LiDAR Quality Assessment Report

UT_Southern_B2_2018

NGTOC
 2019-03-21
 Brian Pfeiffer

Checkpoint Distribution Image

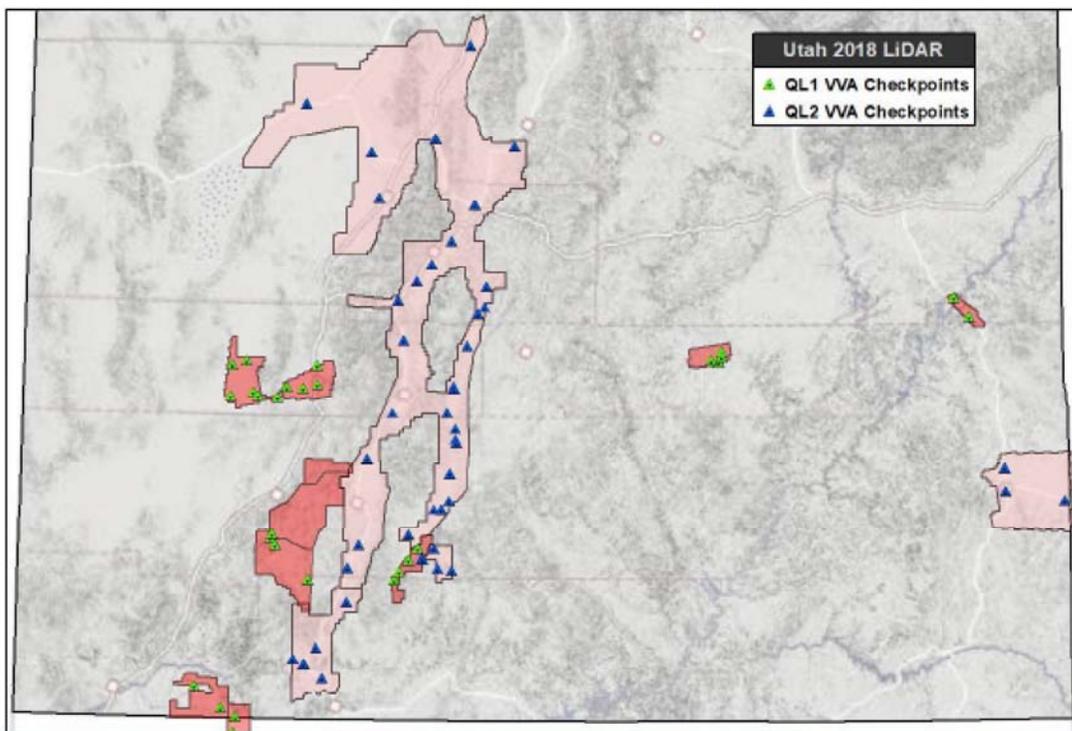
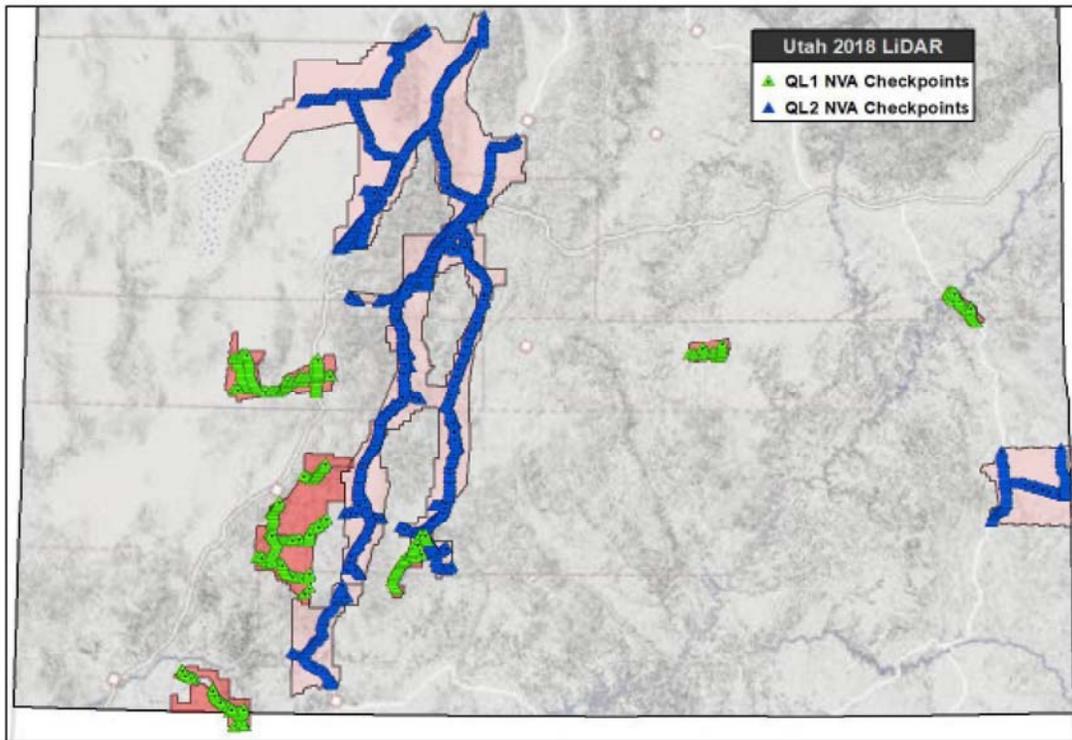
<i>Reviewed Unit:</i>	<input type="text" value="Centimeters"/>
<i>Reviewed # of checkpoints:</i>	<input type="text" value="3,431"/>
<i>Reviewed RMSEz:</i>	<input type="text" value="7"/>
<i>Reviewed Vertical Accuracy (RMSEz * 95th CI)</i>	<input type="text" value="13.7"/>

<i>Required Unit:</i>	<input type="text" value="Centimeters"/>
<i>Required # of checkpoints:</i>	<input type="text" value="568"/>
<i>Reviewed Vertical Accuracy (95th percentile)</i>	<input type="text" value="17.9"/>

Based on this review, the USGS accepts the vertical accuracy.
